**Tuesday, January 12, 2021  
Medway Planning and Economic Development Board  
155 Village Street  
Medway, MA 02053**

## **MEDWAY MILL SITE PLAN:**

## NCE JOB MEMO 2020-039 Revised

SUBJECT: Noise Predictions for Rooftop HVAC Equipment

**Table 2: Sound pressure levels at 1 meter from manufacturer's specification sheet**

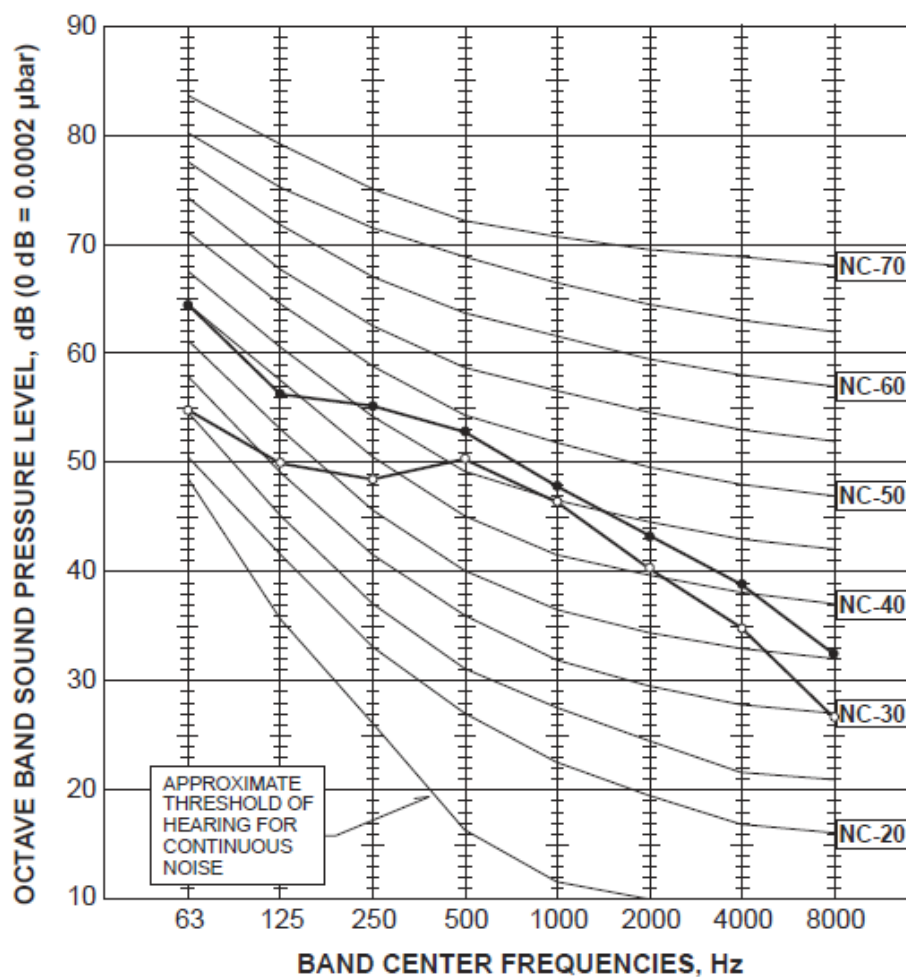
In my opinion, there is still a problem with the octave bands and A-weighting used in the NCE calculations. They have assumed that the manufacturer's specified octave band sound power levels for the HVAC unit are unweighted. However, the summing math doesn't work unless we assume that they are A-weighted. When I A-weight the octave band power levels, convert them to energy and add them up, I get an overall (assumed) A-weighted sound power level of 68.2 dBA, not 75 dBA, as the manufacturer specifies. However, if we assume that the octave band levels are A-weighted already, the energy sum is 76.4 dB – much closer to 75. Unless the manufacturer is being extraordinarily conservative with his specified A-weighted sound power level, the math strongly suggests that the values are already A-weighted (which is not an unheard of way to specify sound power levels). Therefore, the octave band would have to be unweighted before being propagated to the property line and compared with the Medway standards.

1. The overall A-weighted values in the Town of Medway tables are not mixed up with the unweighted values – the overall unweighted value is not presented in the Table. Similarly, in the original table presented, the overall unweighted values were not presented. To avoid confusion, I did present both values in the final table in the revised document. I did notice, however, in the original table that there was a mistake in the calculated A-weighted overall levels – they were actually lower than presented.

THIS PHOTOMETRIC PLAN IS BASED SOLELY UPON PROPRIETARY INFORMATION SUPPLIED BY THE LUMINAIRE MANUFACTURER AND CLIENT RECOMMENDATION.

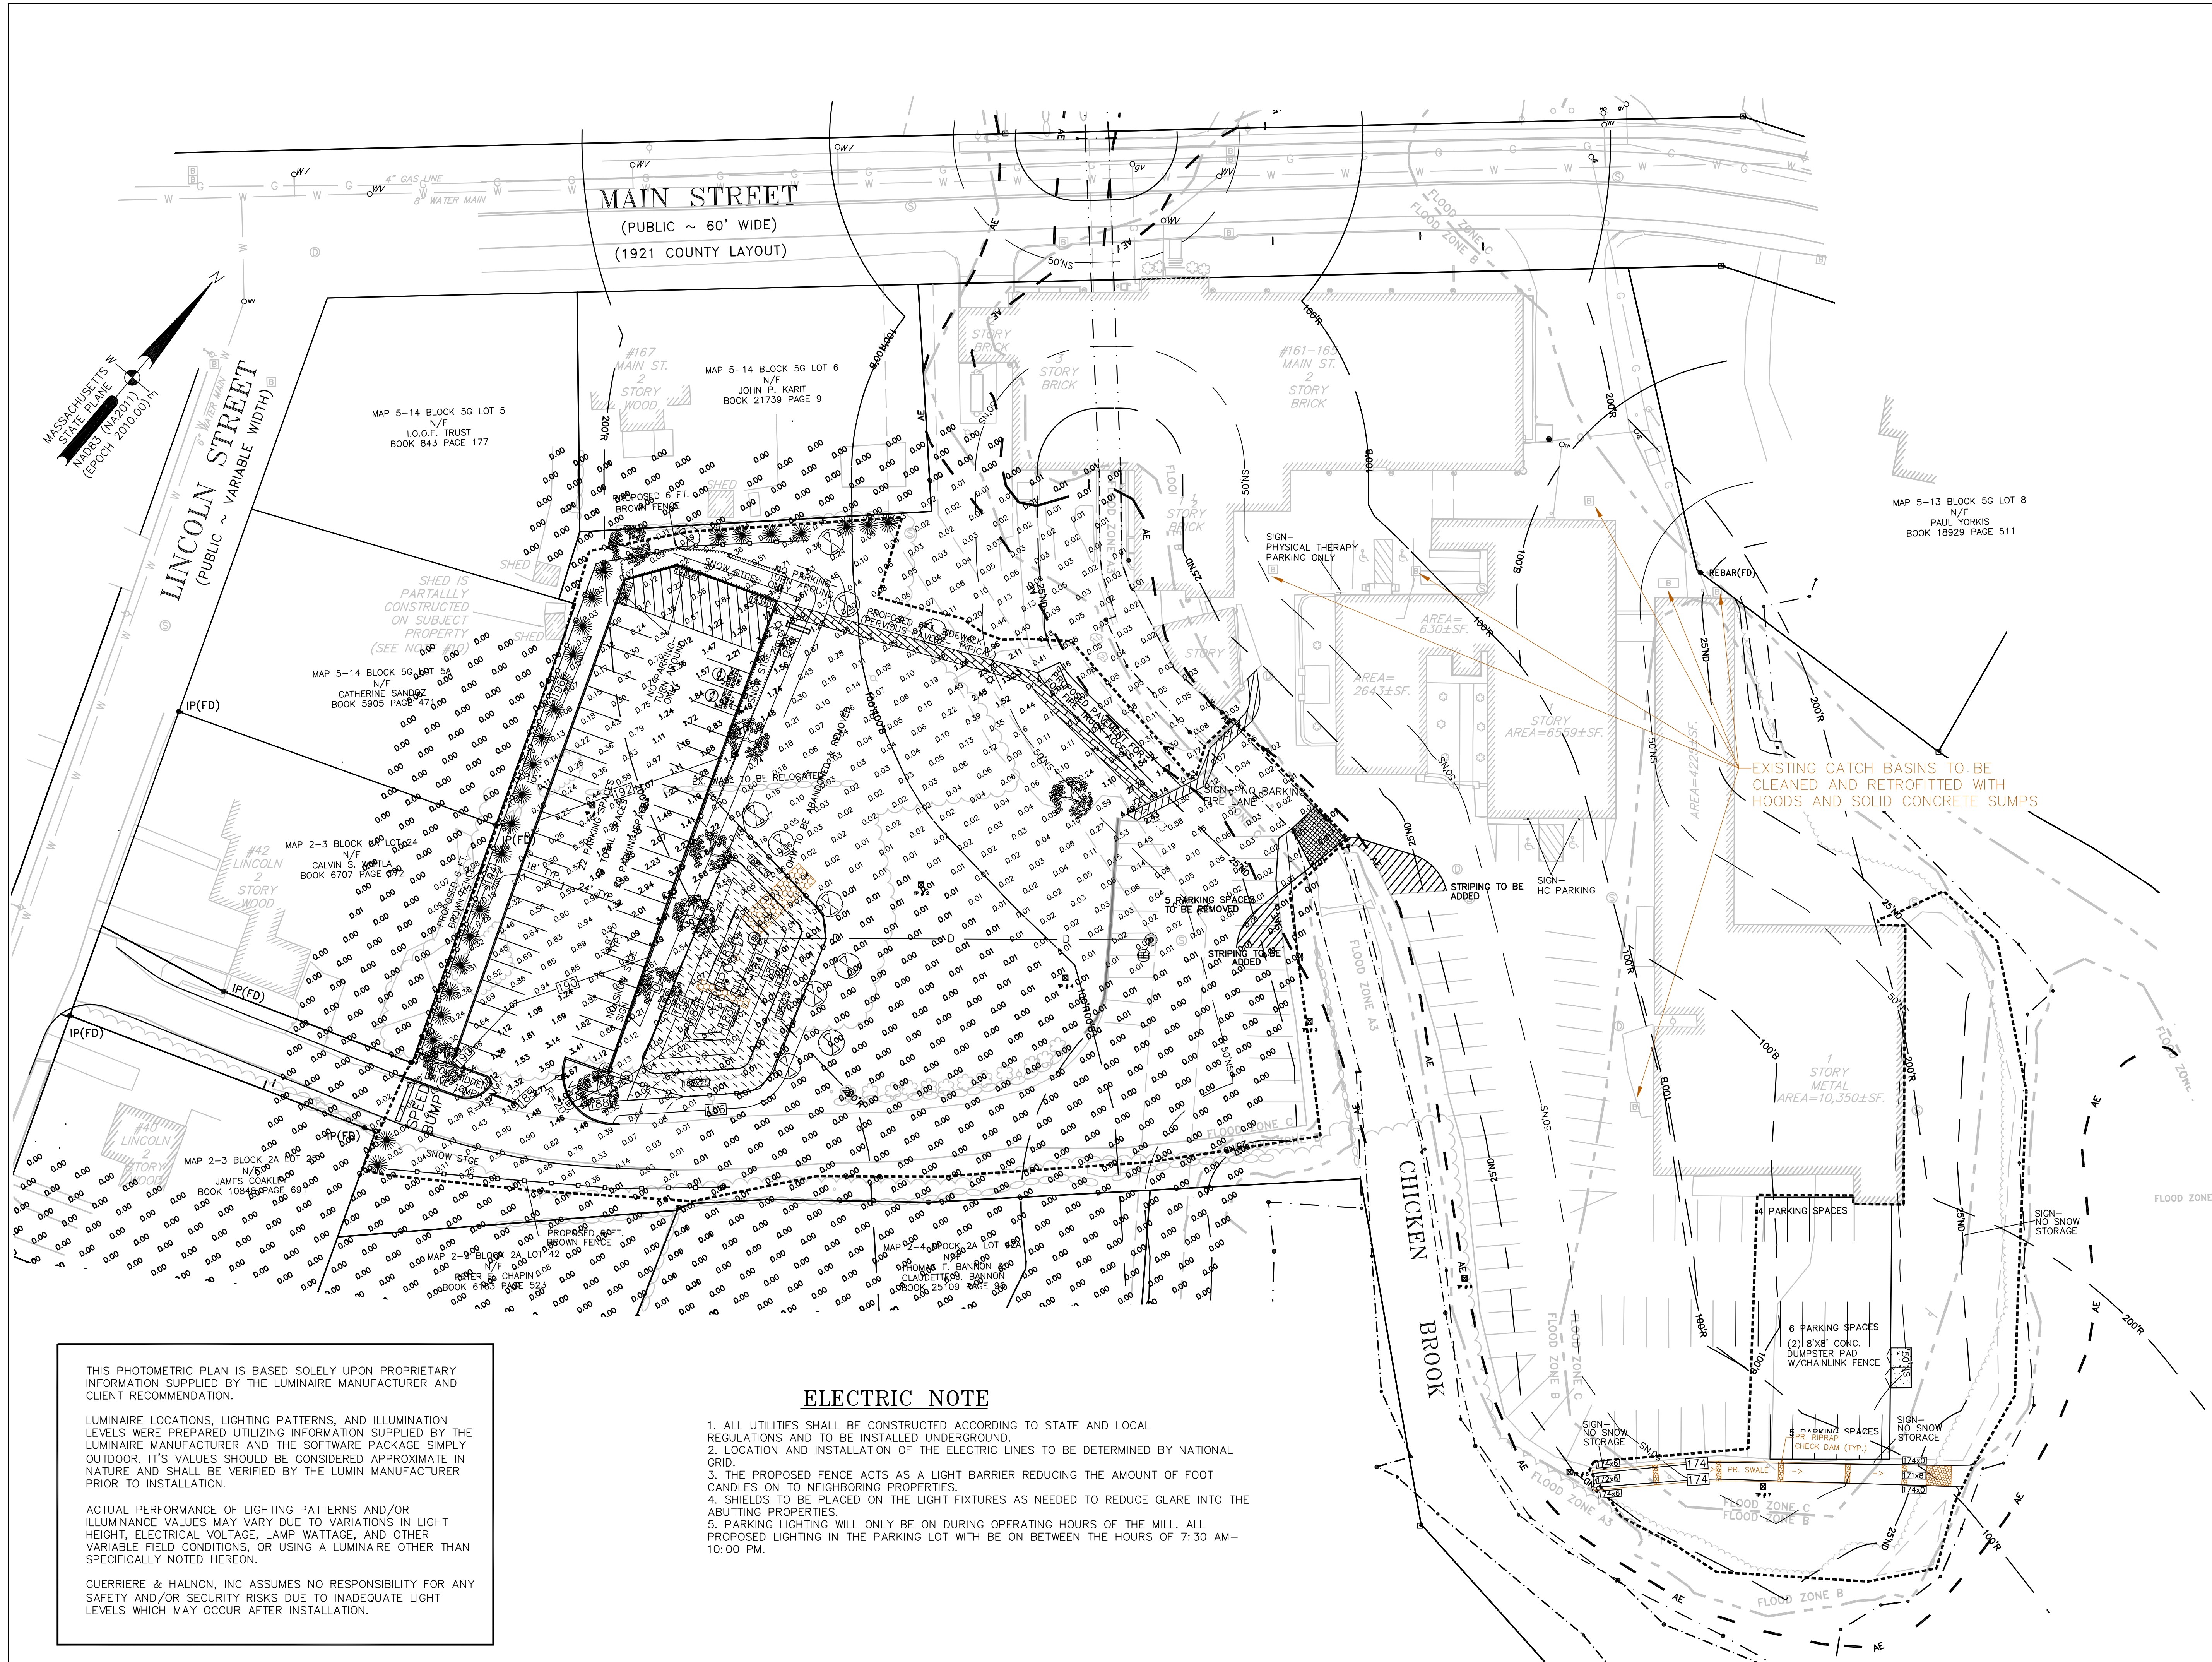
The photometric plan was reviewed. The light posts are located on the east side of the parking lot. Member Hayes suggested they be relocated to the west side of the parking lot and include shields to reduce the glare from the lights on the abutters to the west. The stormwater system has been designed for a 100-year storm. The pipe sizing is adequate. Consultant Bouley noted that the revised stormwater plan has not been discussed with Conservation Commission. (NOTE –
